PCN – Product Change Notice

PCN #: VE20220509

Product packaging improvement for product shipped in JEDEC Trays.

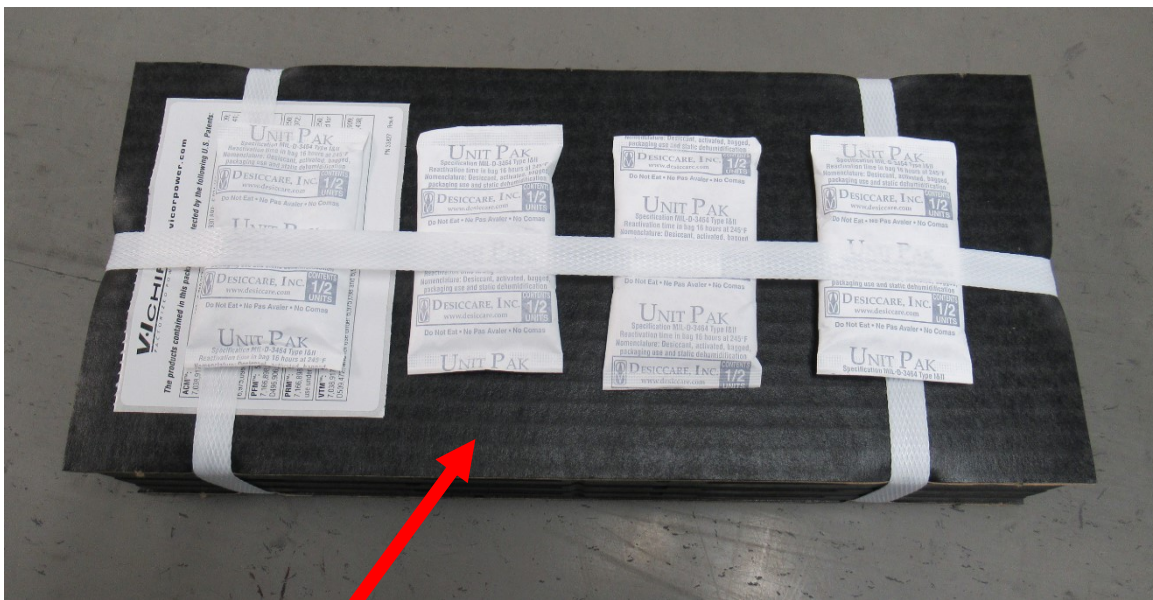
VICOR will replace ESD safe corrugated cardboard packing material with ESD Vacuum Formed Plastic Cap Tray.

Image of ESD Corrugated Cardboard Packaging being replaced.

Image of ESD Vacuum Formed Plastic Packaging being implemented.

The purpose of this change is to reduce MSL moisture levels and provide better product protection.

- Using ESD Vacuum Formed Plastic Cap Tray to replace the ESD Cardboard for top and bottom packaging will reduce overall moisture or water volume content inside the MSL Shipping Packaging by approximately 81% (~0.31255 in³ to 0.06064 in³).
- ESD Vacuum Formed Plastic Cap Tray packing configuration passes all Drop Testing per DP-0444 and in compliance with IPC-9592B, 5.2.13. Worst case testing performed on heaviest product configurations. BCM6135, NBM2317, BCM135. A total of 26 drops data in report.
- ESD Vacuum Formed Plastic Cap Tray conforms to ANSI/ESD S541-2019 Static Dissipative Surface Resistance Planar – ANSI/ESD STM11.11.
